FINAL DRAINAGE REPORT
for
FALCON MARKETPLACE

El Paso County, Colorado

SF-19-001

Engineering Review

Detention Basin Outlet Structure Design

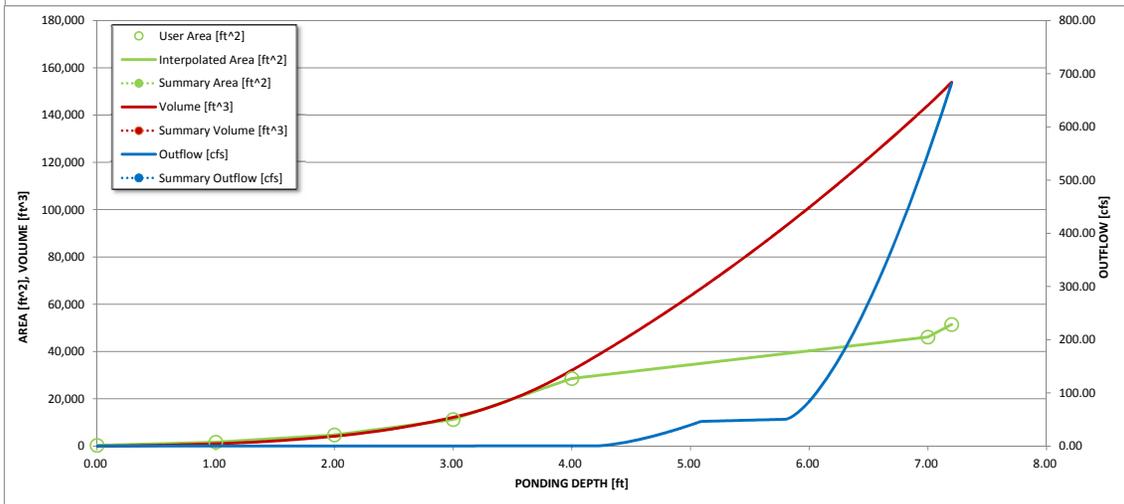
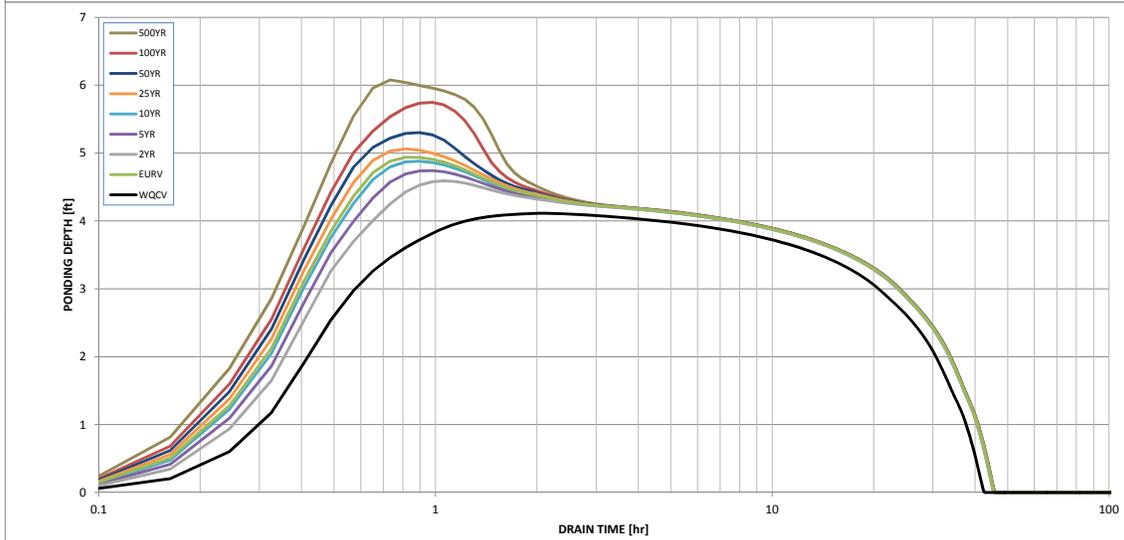
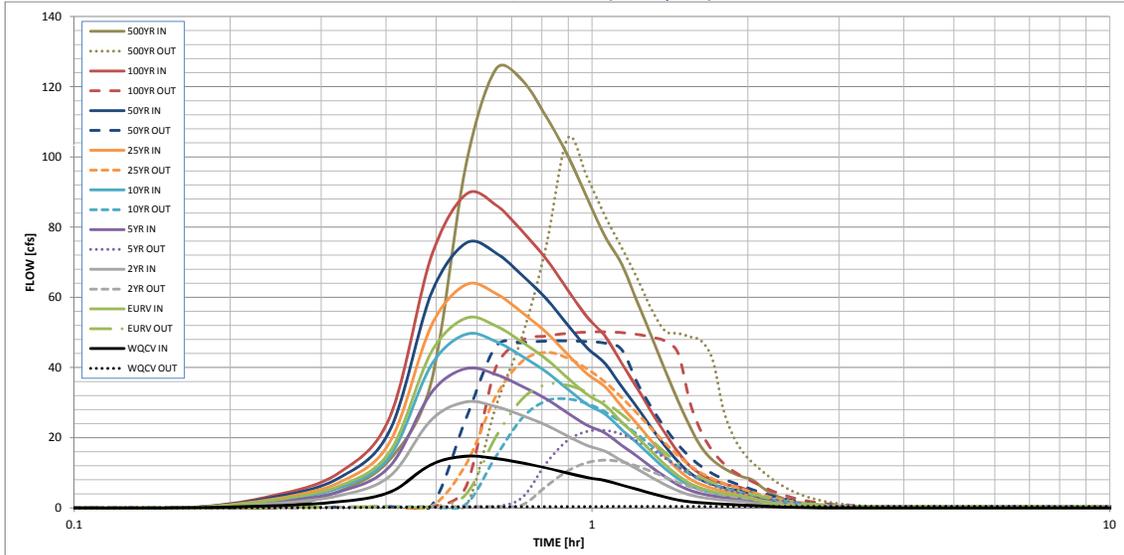
The WQCV needs to be released over 40 hours with the EDB design.

Detention Basin Outlet Structure Design

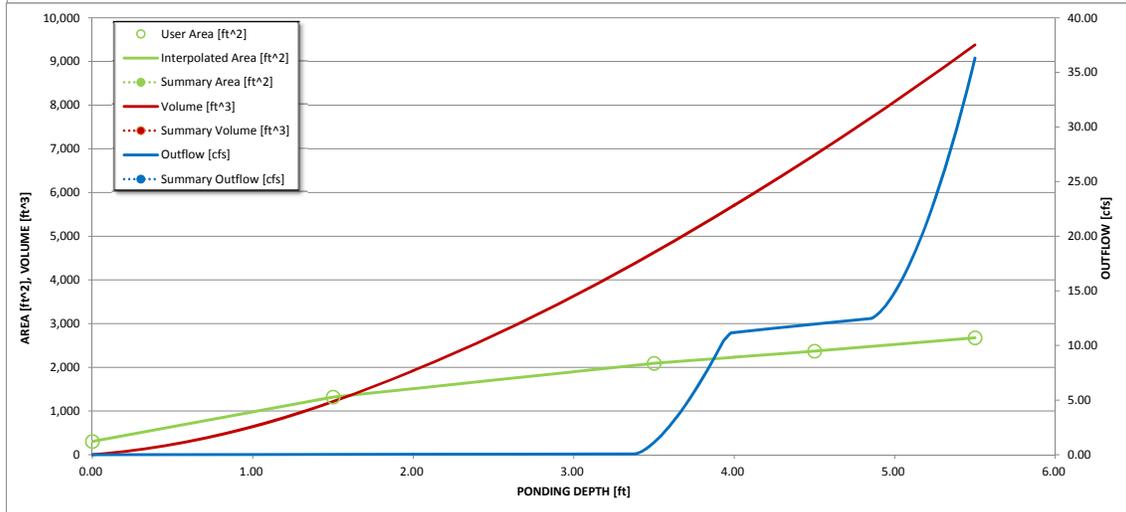
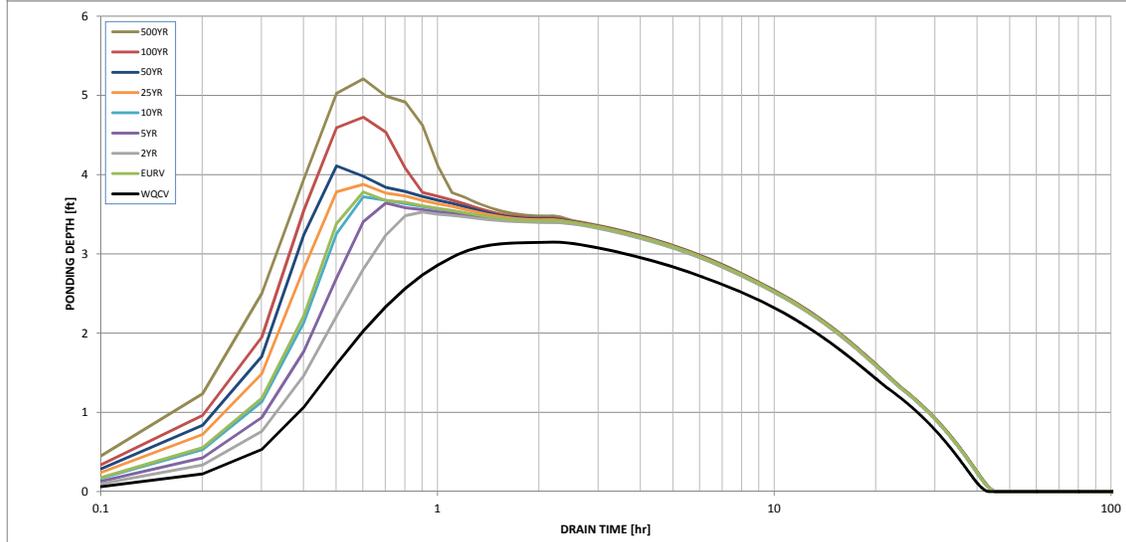
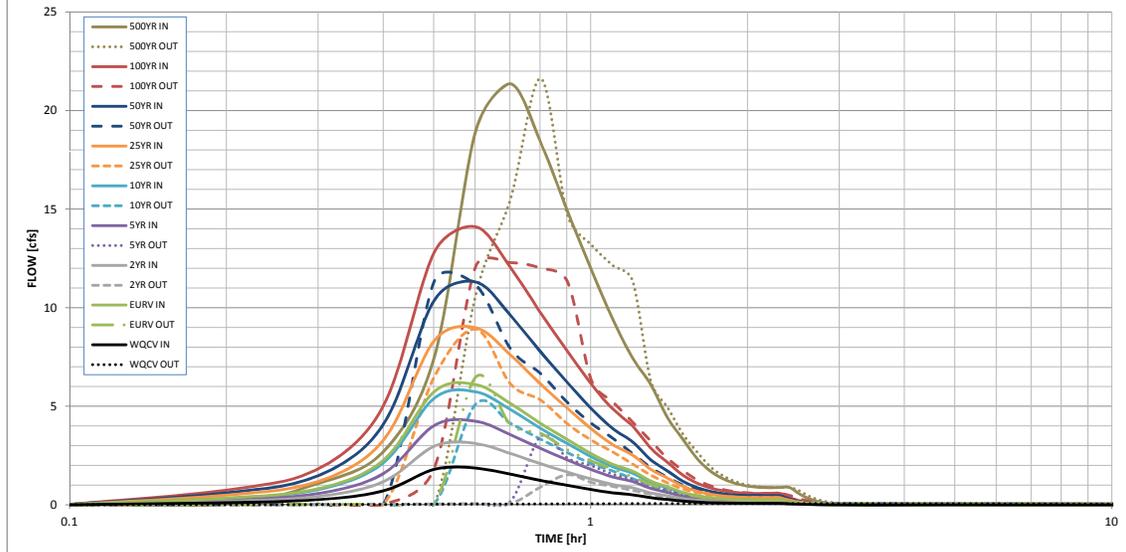
The WQCV needs to be released over 40 hours with the EDB design.

PROPOSED DRAINAGE CONDITIONS

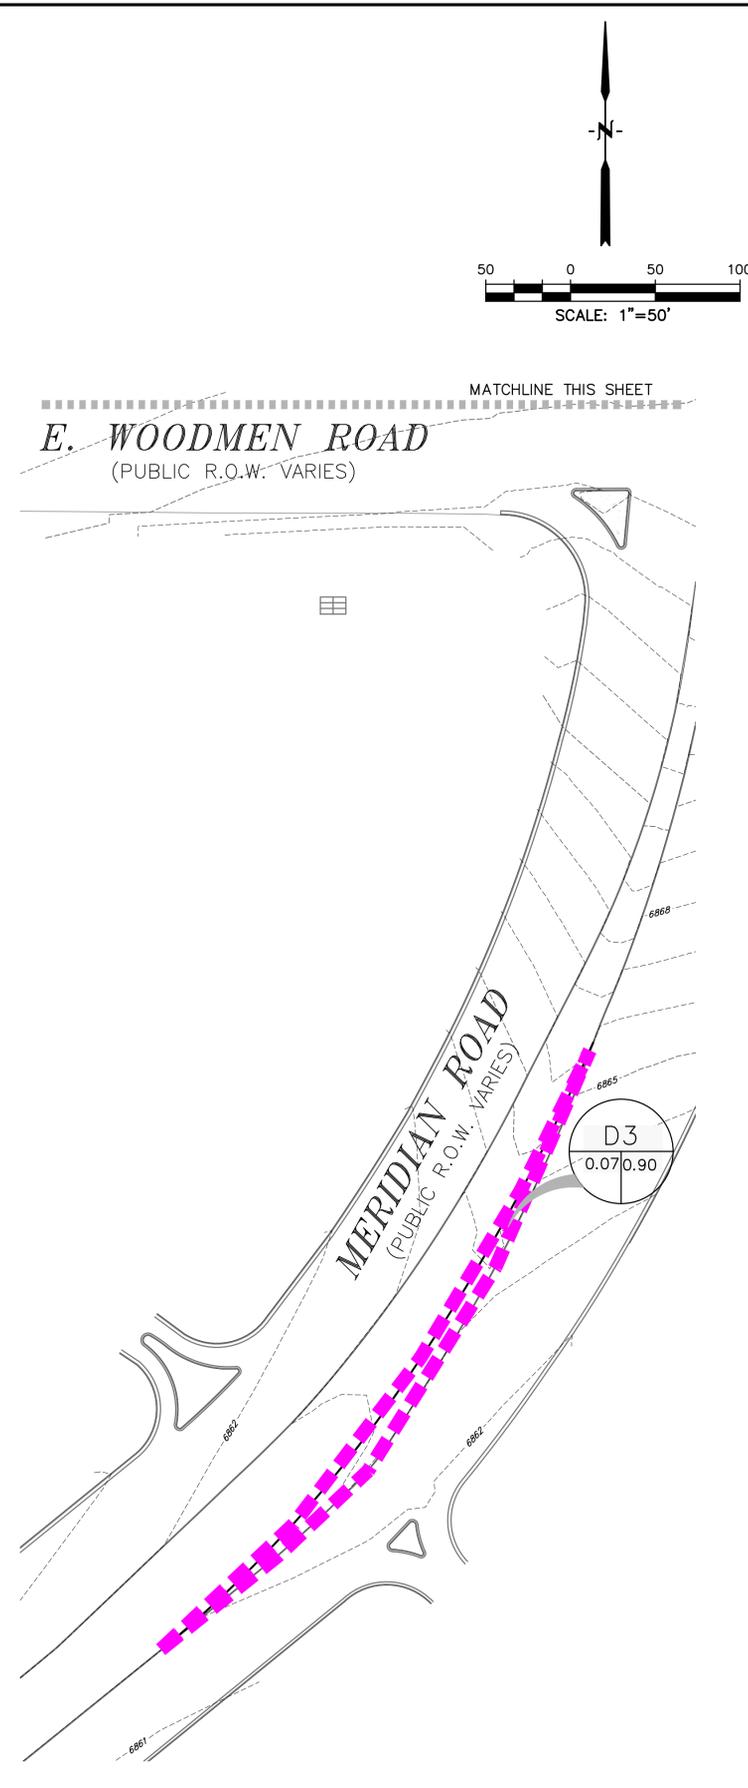
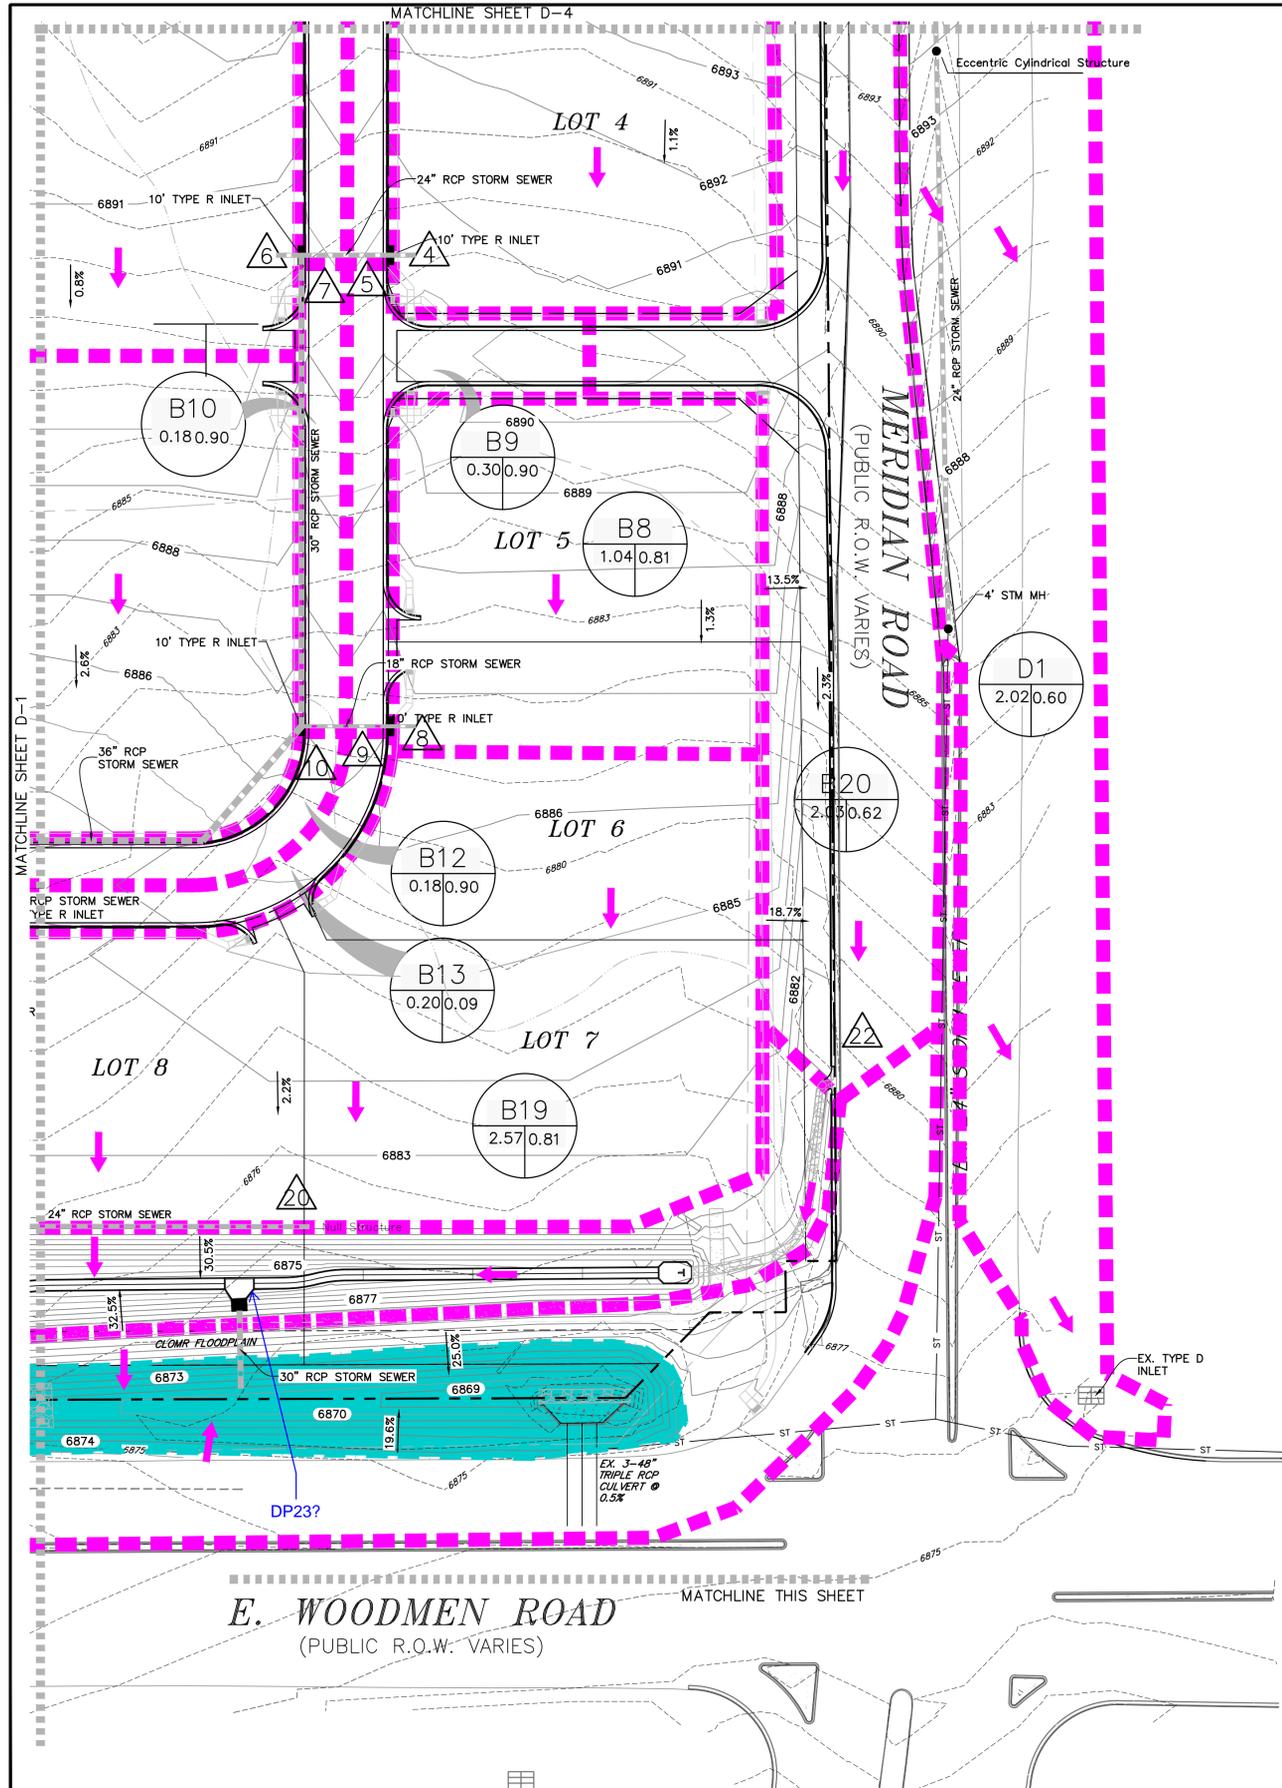
Show all drainage easements.

POND #2 & OPEN CHANNEL SECTION D-D
NO SCALE

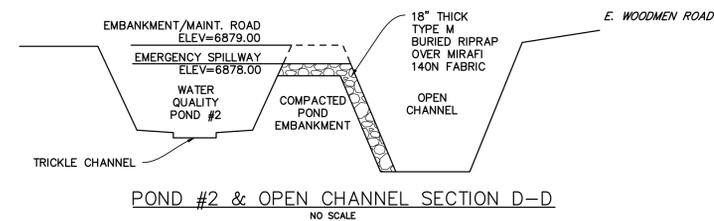
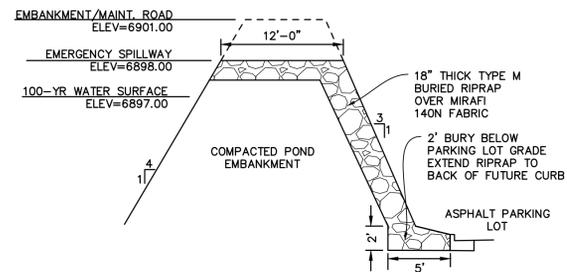
See comment letter.
